SERVICE DIRECTIVE BULLETIN

SERVICE DIRECTIVE BULLETIN NO. T-039

Revision 3

1. SUBJECT: Cyclic Trim System – Cyclic Trim Assembly Kit for the Lateral and Longitudinal Trim Actuator Assemblies
2. MODEL: TH-28, 480, 480B
3. EFFECTIVITY: S/N 5138 and prior
4. REFERENCE: Enstrom TH-28/480 Series Maintenance Manual, Latest Revision
5. BACKGROUND:

Figure 1: Lateral Cyclic Trim Switch Module and Trim Actuator Assembly

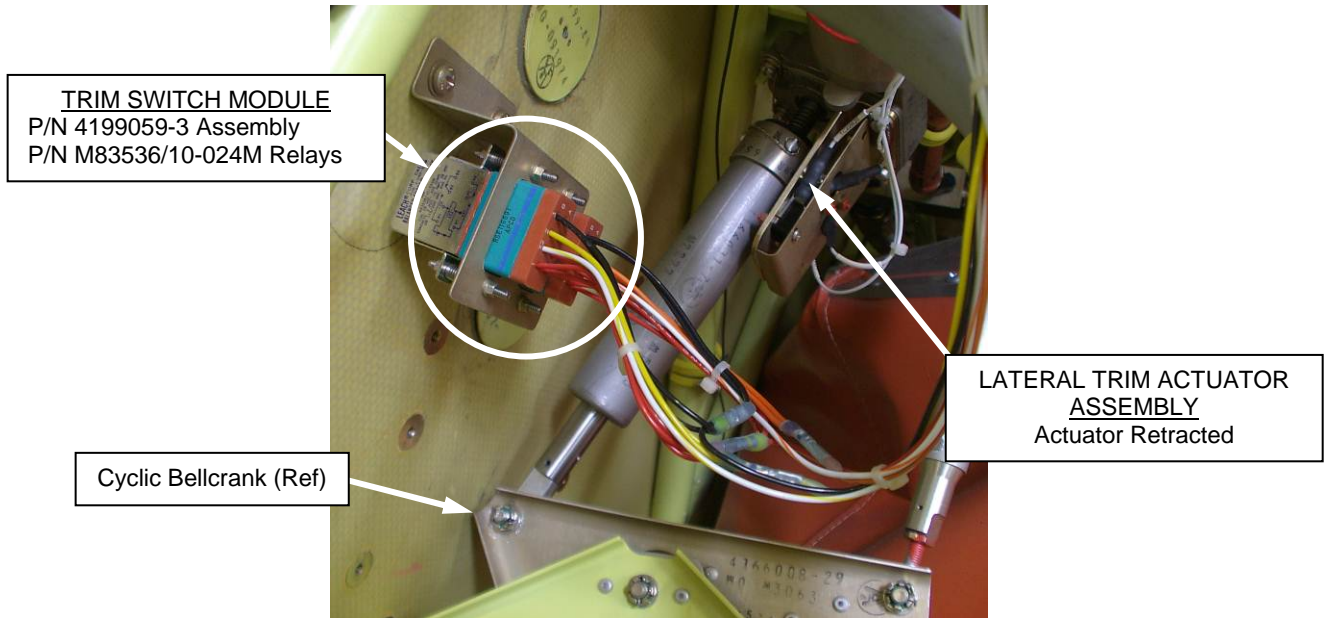
This condition can only occur on aircraft equipped with P/N 4199059-3 Trim Switch Module Assembly containing a M83536/10-024M Trim Relay (Figure 1). Aircraft equipped with P/N 4199059-1, 4192102-4 or 4192102-903 Trim Switch Module Assembly containing a solid state relay (Figure 2) are not at risk because those switches do not have a failure mode that could cause a runaway.

Figure 3: Trim Actuator Assembly (Lateral Trim Actuator Retracted)

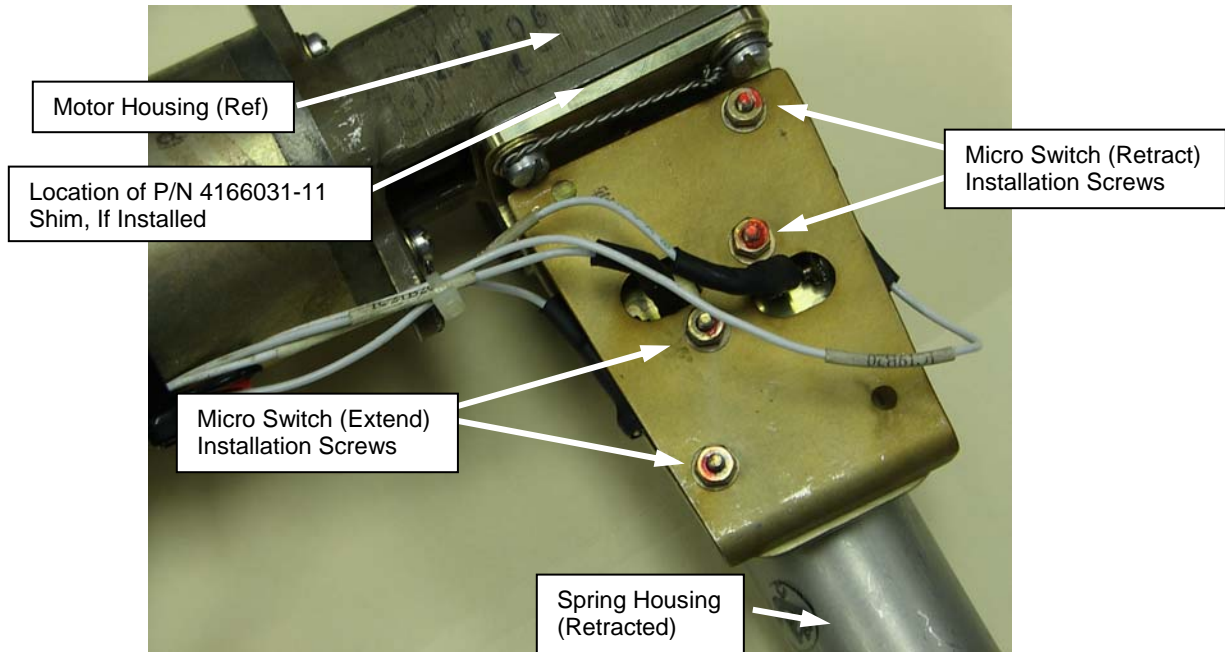
- A. Determine if the trim actuator assembly has shims between the switch plate and the housing (Figure 3 and Figure 6). If the assembly contains shims complete the following:
 - 1. Using the cyclic control, fully extend the motor.
 - 2. Measure the distance from the motor housing to the bottom of the spring capsule (Figure 6). Record this distance ('Max') in Table 1.
 - 3. Repeat for the second trim actuator assembly, if necessary.
- B. Set the lateral and longitudinal trim actuator assemblies to a neutral position (mid-travel).
- C. Disconnect the battery.

1. To adjust the spring housing travel, loosen the switch mounting hardware to set the switch position(s) as necessary to bring the spring housing travel within limits. For example, to shorten the spring housing extension, loosen the switch mounting hardware for the extending switch and adjust the switch position inward (Figure 3).
2. Check spring housing travel to verify that proper adjustment was made.

Figure 4: Spring Housing and Cyclic Bellcrank Clearance

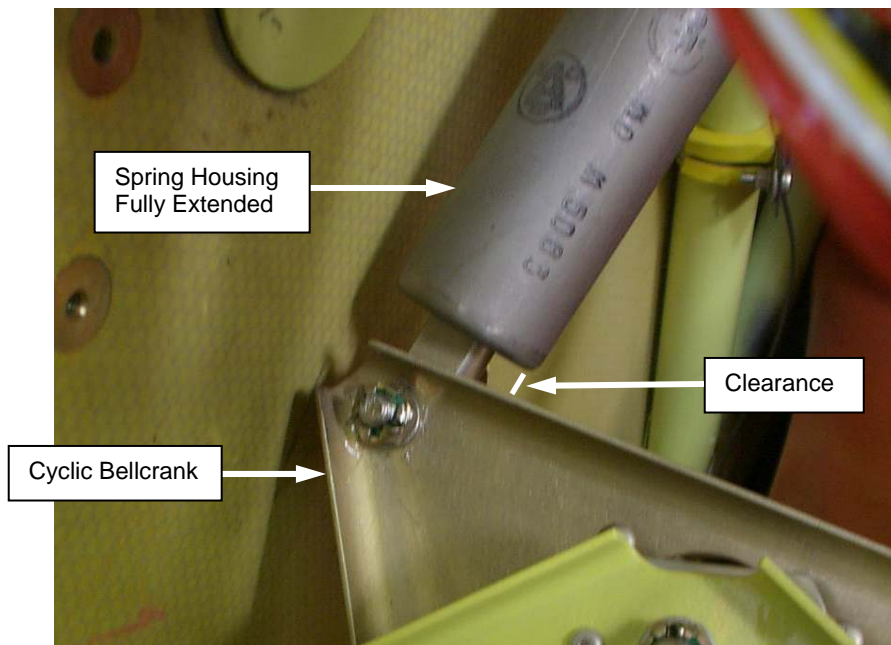
1. Extend the actuator to full travel. (Trim full forward or full left).
2. Move the cyclic full Aft/Right.
3. Verify there is clearance between the end of the spring capsule and the bellcrank (Figure 4).
4. If the spring capsule contacts the bellcrank, remove the P/N 4166031-11 shims from between the switch assembly and the actuator and re-install and re-safety the switch assembly.
5. Repeat steps 1-4 as required.
6. If the bellcrank contacts the spring capsule and there are no shims, re-check the travel in accordance with step N.
7. If the travel is correct and the spring capsule still contacts the bellcrank, contact Enstrom Customer Service.

Figure 5: Maximum Travel Limit at 1.95"

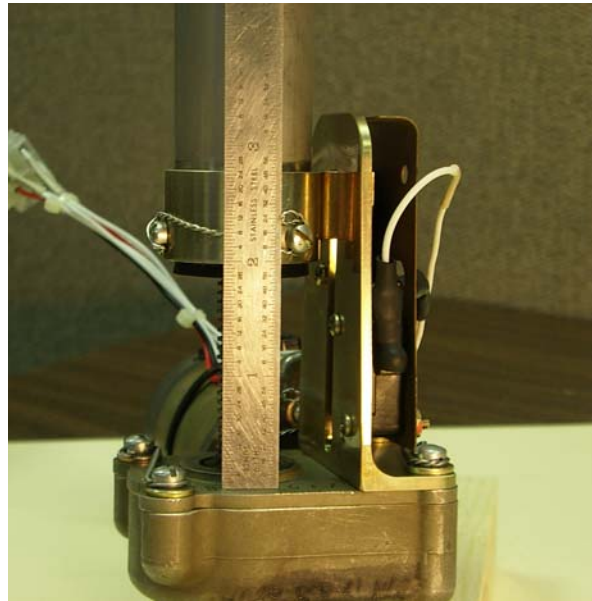
2. Install and reconnect the battery.
 3. Both trim actuator assemblies can be electrically tested from either the left or right hand side of the aircraft, whichever location is more convenient. Set the trim actuator assembly on a portable bench or suitable stable surface to perform the check and adjustments.
- N. Check the spring housing travel and adjust the switch positions to ensure that the retracted and extended spring housing travel are within the limits specified on the drawing or as determined in the note below. Enlist a second person to assist with the cyclic operation while conducting measurements and adjustments (Figure 5).

If no shims are installed, the retracted travel or minimum stroke limit is 0.125" +0.05"/-0.00". The extended travel or maximum stroke limit is 1.95" +0.00"/-0.05". If shims are installed, the extended travel or maximum travel limit is the 'Max' dimension measured in Step A.2 +0.00"/-0.05". The minimum travel limit 'Min' is the difference between this dimension and 1.825" +0.05"/-0.00" (Figure 6).
